18 FEDERAL AGENCIES

Palmdale - Burbank - RECORD #4027 DETAIL

Review of Draft Biological Evaluation, 1/21/2022

Figure 1 –Wildlife Movement Opportunities, Looking North from Agua Dulce Canyon Road, through the Linkage Design, Across the SR 14 Freeway Corridor and Roadkill Data

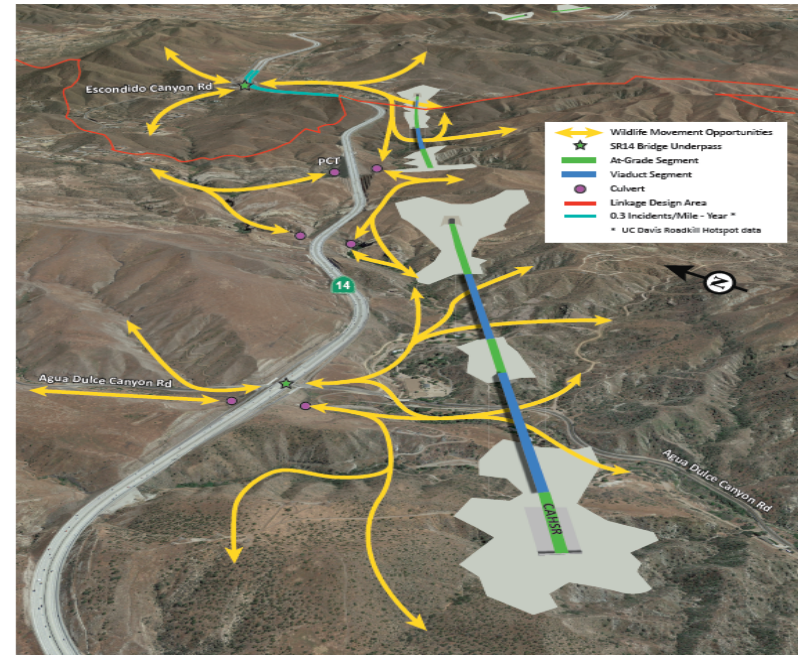
The commenter suggests the majority of available wildlife crossings will be associated with the viaducts, tunnels, and additional wildlife crossings are part of the built design and align with the existing bridge structures on the SR 14 freeway and high use crossing areas documented by UC Davis roadkill data, illustrated in Figures 1 and 2. Lastly, the commenter notes the viaducts, tunnels and culverts constructed for the build alignment alternatives may be underutilized by wildlife. Regarding concerns about wildlife crossings, the length and spacing of the tunnels and viaducts dispersed throughout the project will provide opportunities for wildlife species to move across a diversity of habitat types including upland, drainage, and riparian. The proposed design features including tunnels and viaducts would provide opportunities for wildlife movement. Refer to Standard Response PB-Response-BIO-3: Wildlife Movement Corridors, for additional information.

Figure 2 - Wildlife Movement Opportunities, Looking North from Stonecrest Road, through the Linkage Design, Across the SR 14 Freeway Corridor and Roadkill Data

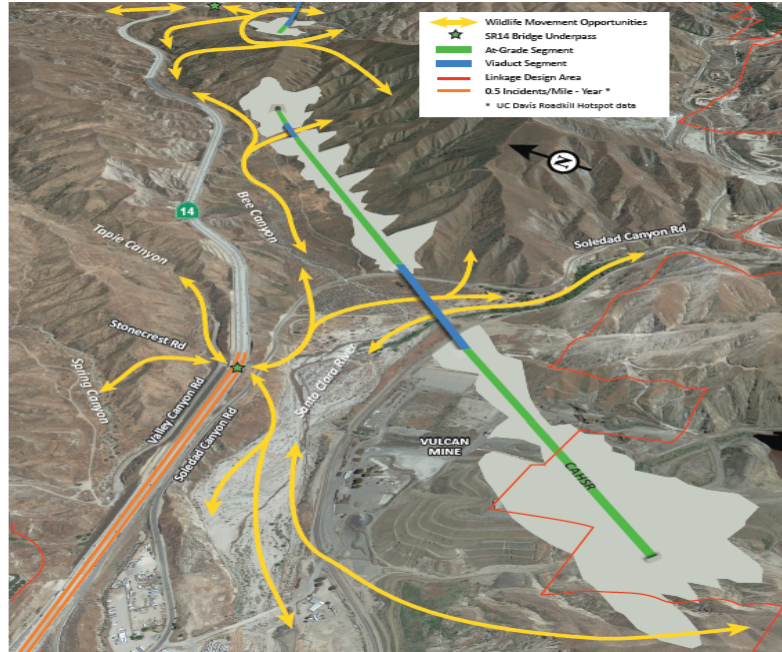
4525-10370

The SR 14 freeway and the California Aqueduct are the primary barriers to wildlife movement in the area. Figure 5-7 and Section 5.3.1, Existing Crossing Structures, in the WCA identifies potential wildlife crossing opportunities across these barriers. Photographs of each of the crossing opportunities are provided in Appendix C of the WCA. Figure 4-5 in the WCA shows the spatial relationship between the existing bridges and these permeable large tunnel and viaduct segments associated with the Refined SR14 and SR14A Build Alternatives that would maintain wildlife movement consistent with Policy S22.
